Site Plan Analysis

RE: All Saints Church Storm Water Management Investigation

All Saints Church Storm Water Exhibit

Columbarium and Memorial Gardens Project Neighborhood Meeting

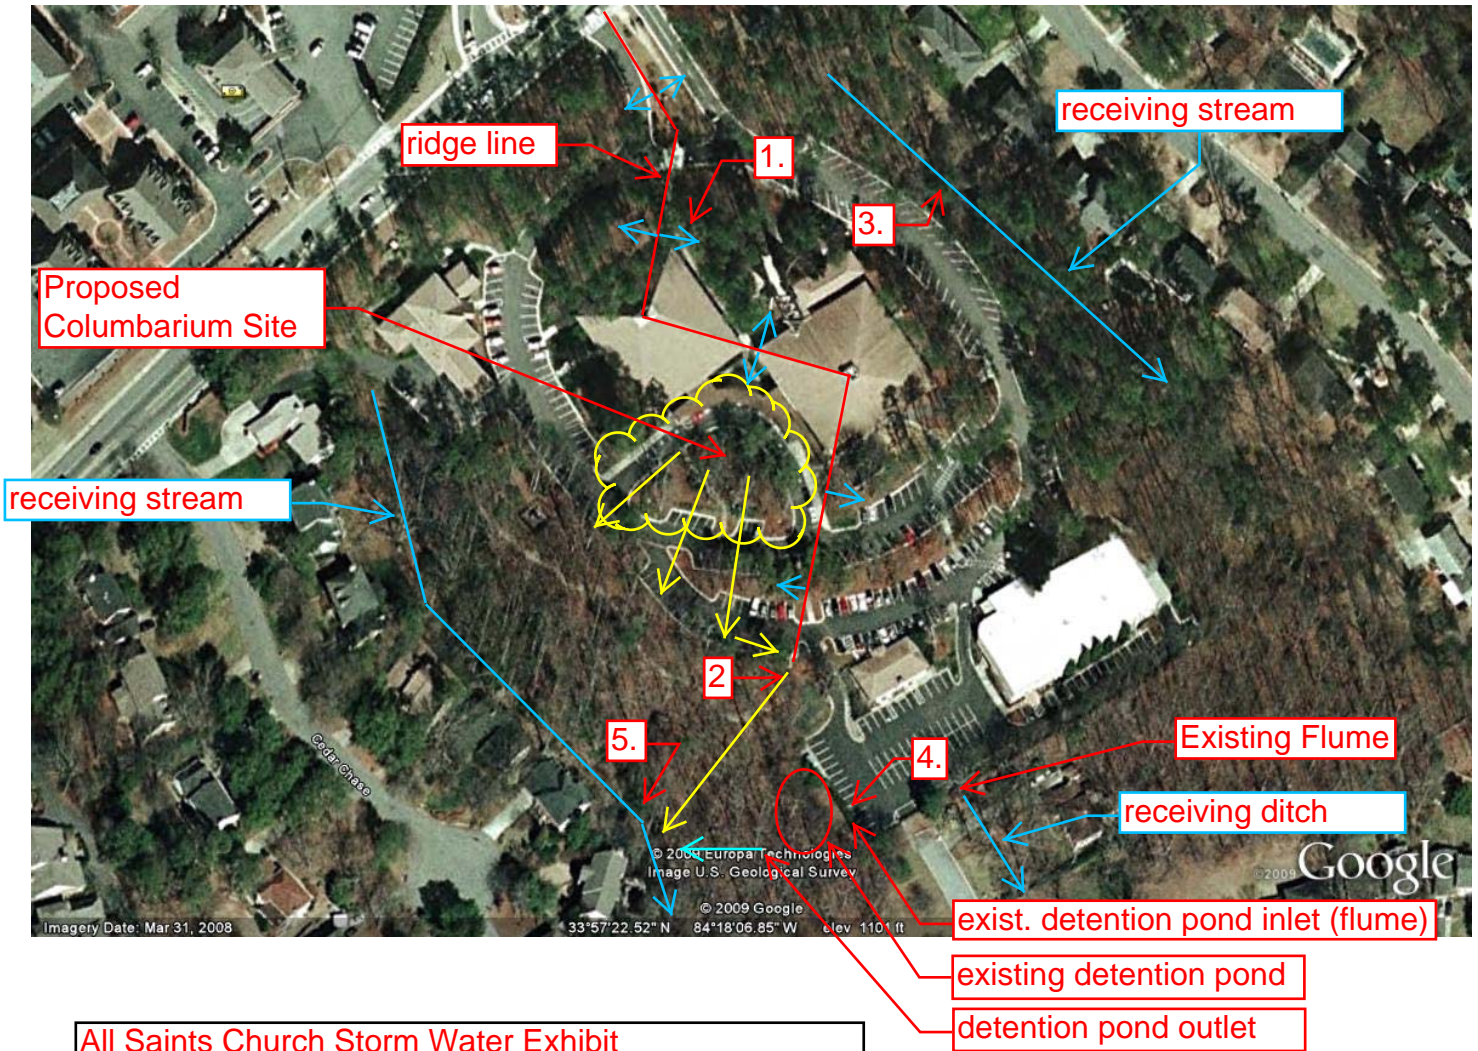
The site is characterized by a ridgeline running through its middle. Water flows away from this ridge to the left and right sides of the property, where it is intercepted by receiving streams. The proposed columbarium will be constructed in the “left” side drainage basin. Currently, all of its water flows undetained and untreated, through the outdoor chapel, to the left side receiving stream, and then through culverts on Sandell Drive.

There is an existing detention pond on the property which catches much of the runoff from the activity building parking lot. Left in its current state, this detention pond will not receive any runoff from the proposed columbarium site. Accordingly, prior to receiving a land disturbance permit, the applicant must show how they will address both water quality and quantity storm water impacts from the project. The City’s development regulations require this for storm water quantity impacts on sites disturbing greater than 5000 square feet and for all storm water quality impacts regardless of project size.

1. Water flows away from the ridge line shown, as indicated by the blue flow arrows.
2. water on the left side of the ridge line flows through the parking lot to the existing flume
3. Water to the right of the ridge line flows to the stream to the right of the circular parking area.
4. Water from the activity building parking lot flows to the existing detention pond.
5. Water from the proposed Columbarium will bypass the existing detention pond and flow into the stream on the left side of the property.
